**RE: MARBERRY FOUR PLEX (L16-D34). ENGINEER'S  
CERTIFICATION FOR CERTIFICATE OF OCCUPANCY  
APPROVAL. ENGINEER'S CERTIFICATION DATED FEBRUARY  
23, 1998.**

**RE: MARBERRY FOUR PLEX (L16-D34). DRAINAGE PLAN FOR BUILDING PERMIT  
APPROVAL. ENGINEER'S STAMP DATED JUNE 20, 1997.**

RE: YOUR COMMENTS DATED JUNE 30, 1997 FOR MARBERRY FOUR  
PLEX (L16-D34)

**RE: MARBERRY FOUR PLEX (L16-D34). DRAINAGE PLAN FOR BUILDING PERMIT APPROVAL. ENGINEER'S STAMP DATED JUNE 20, 1997.**

# Channel Capacity Analysis

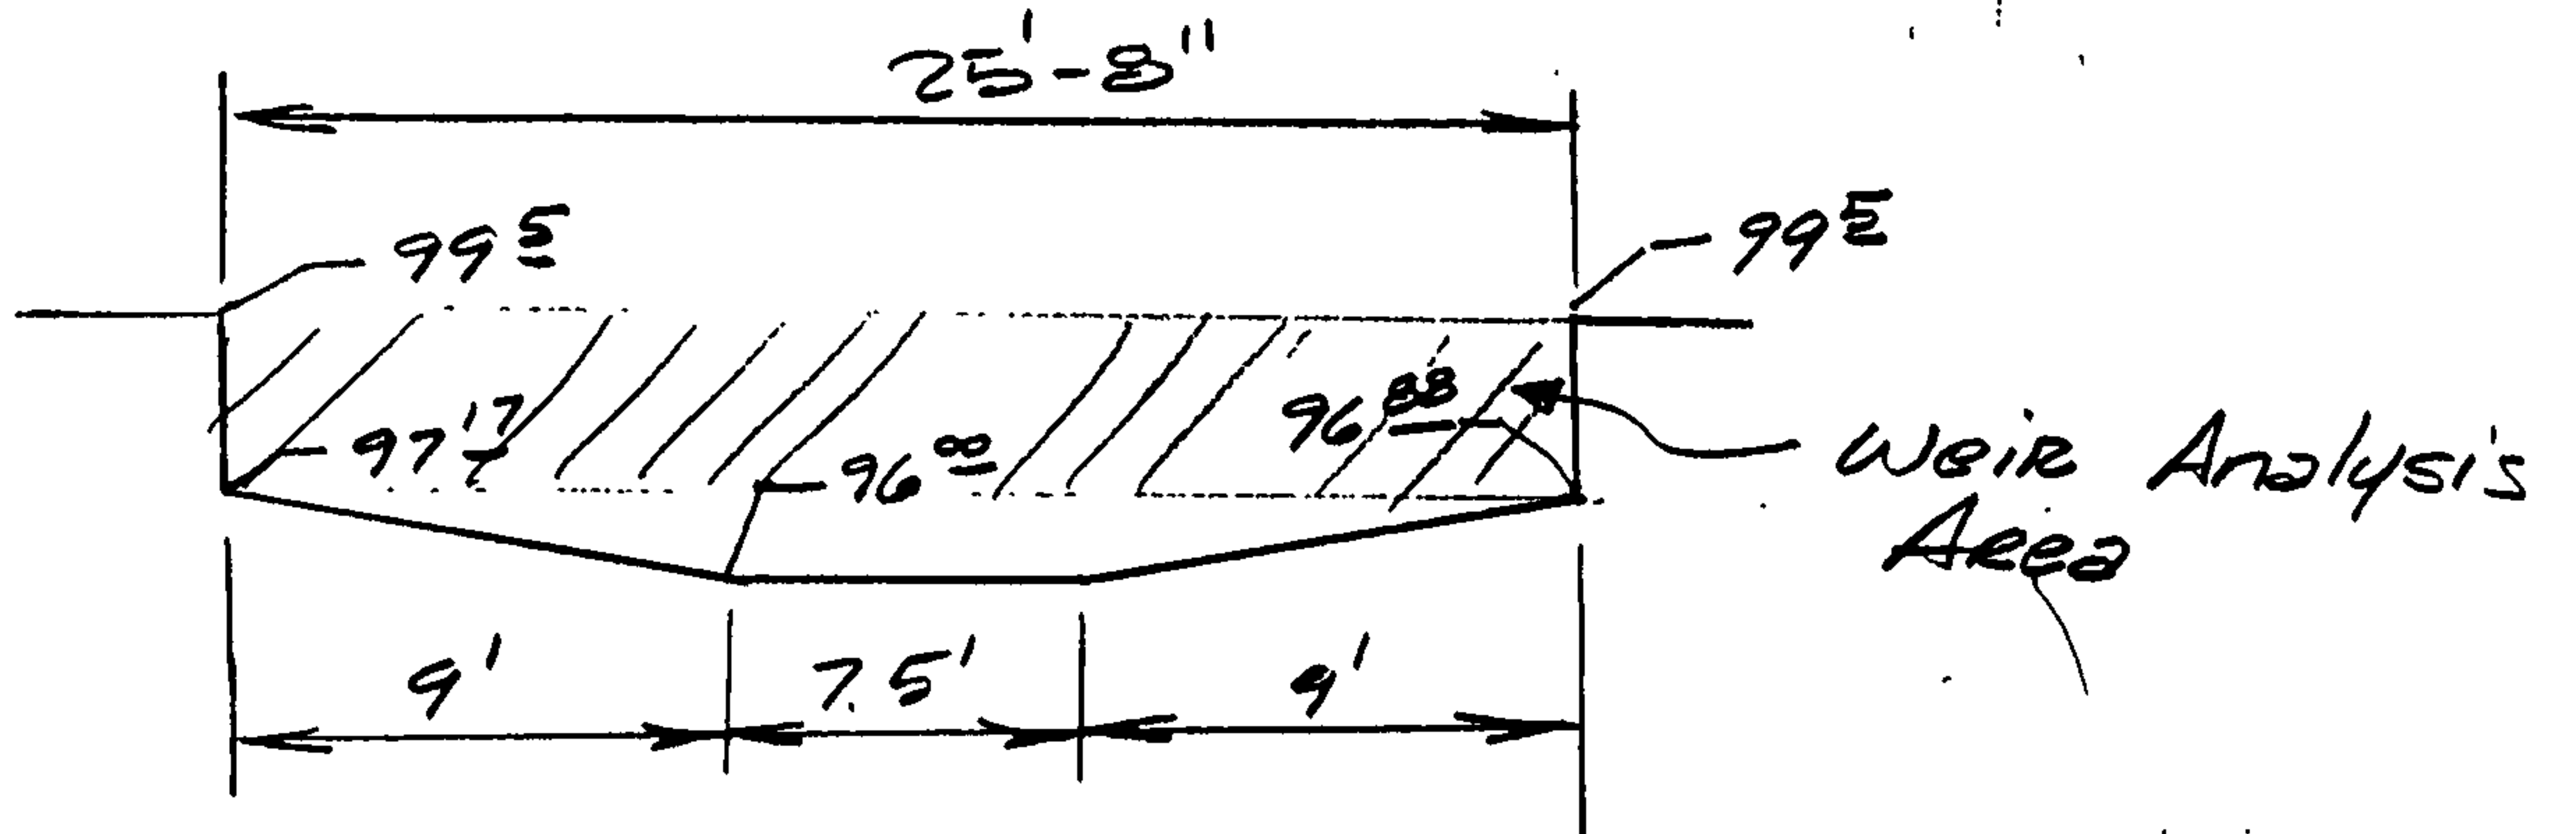
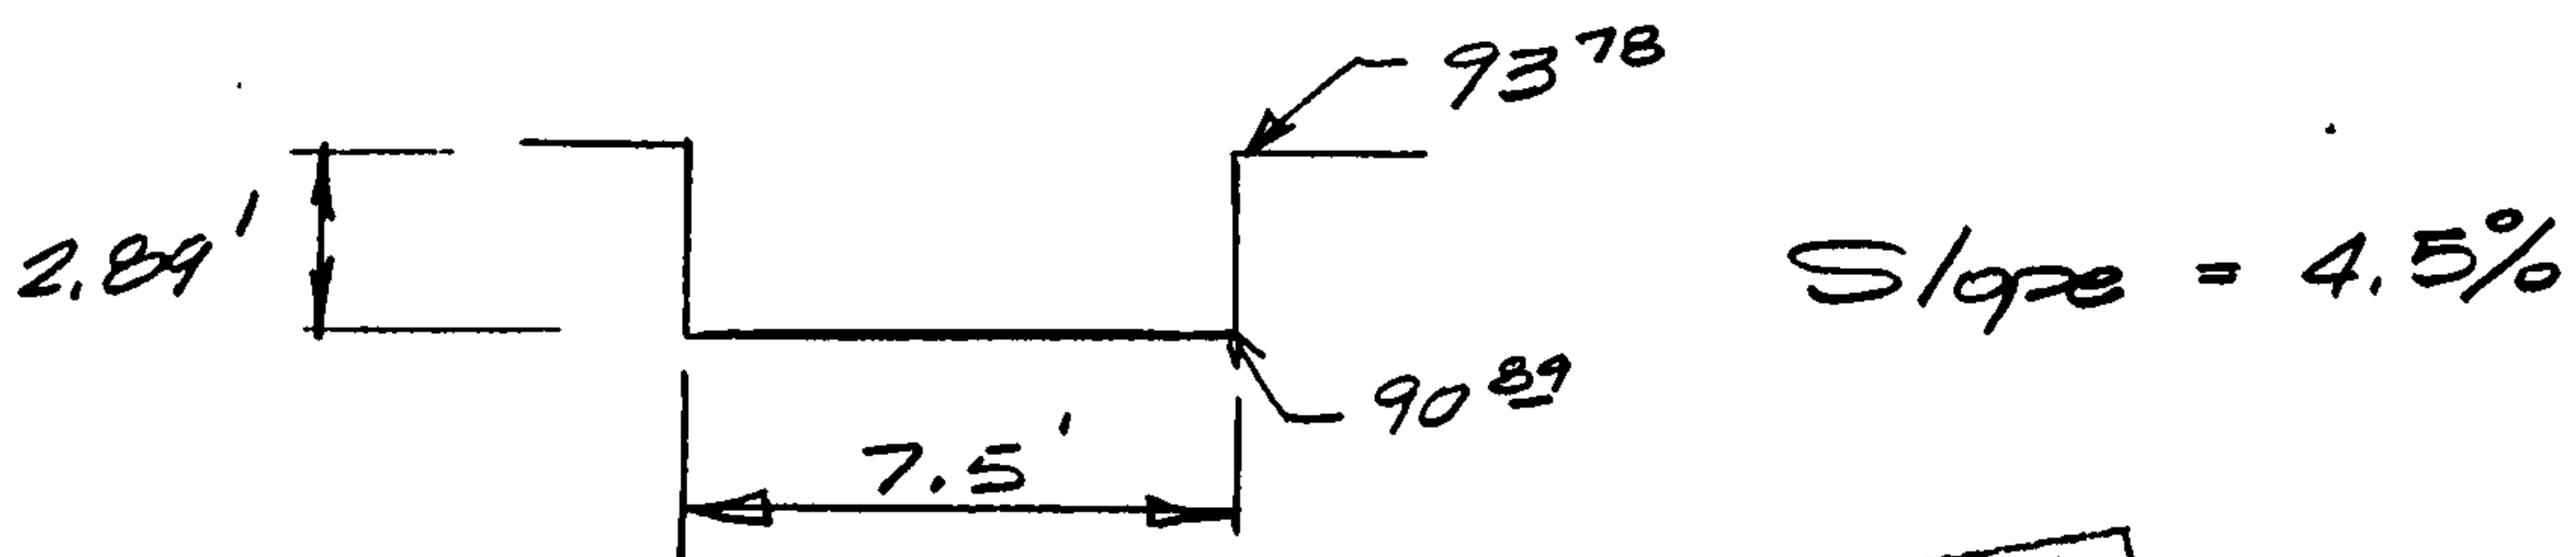
1. The finish floor elevation must be a minimum of 1-foot above the base flood elevation. What is the base flood elevation.
2. The building pad is not to encroach the shaded floodplain area.
3. Please discuss the offsite flows from the east that create this floodplain.

Attached is a cross section at the throat and a weir calculation assuming a rectangular opening, the capacity at this location indicates a flow rate of 274cfs. Also shown is a cross section at the main channel where it is at the narrowest, using a open channel flow program that utilizes a manning's equation indicates a normal depth of 1.06 feet with 1.83 feet of freeboard. In 1991 the City constructed a Intercepting and Detention Facility immediately east of Girard Boulevard which intercepts offsite flows, this may have further reduced the flow rate expected at this location.

1. The base flood elevation assuming none of the above mention drainage improvements were in place would be 5265.5. This is based on taking a cross section at the east side of the four plex, extending this section to the bottom of the channel which has a invert elevation of 5264.5 and adding 1 foot since this is an AO(Depth 1). The finish floor elevation proposed is 5269.83, 4.33 feet above the base flood elevation.
2. Moving the building off the shaded floodplain area would not work since the lot is only 60 foot wide, an exception is requested based on the above calculations provided.
3. See previous calculations.

Cross Section at Throat on Girard Blvd.

Weir:  $Q = CLH^{3/2}$  Assume  $V = 0$

$H = (99.5 - 97.17') = 2.33'$

$L = 25.67$   $C = 3.0$  use Rectangular Section

$Q_{CAP} = 3.0 (25.67) (2.33)^{3/2} = 274 \text{ cfs capacity}$  } 97 cfs overland  
or  $Q_{peak} = 148 \text{ cfs}$
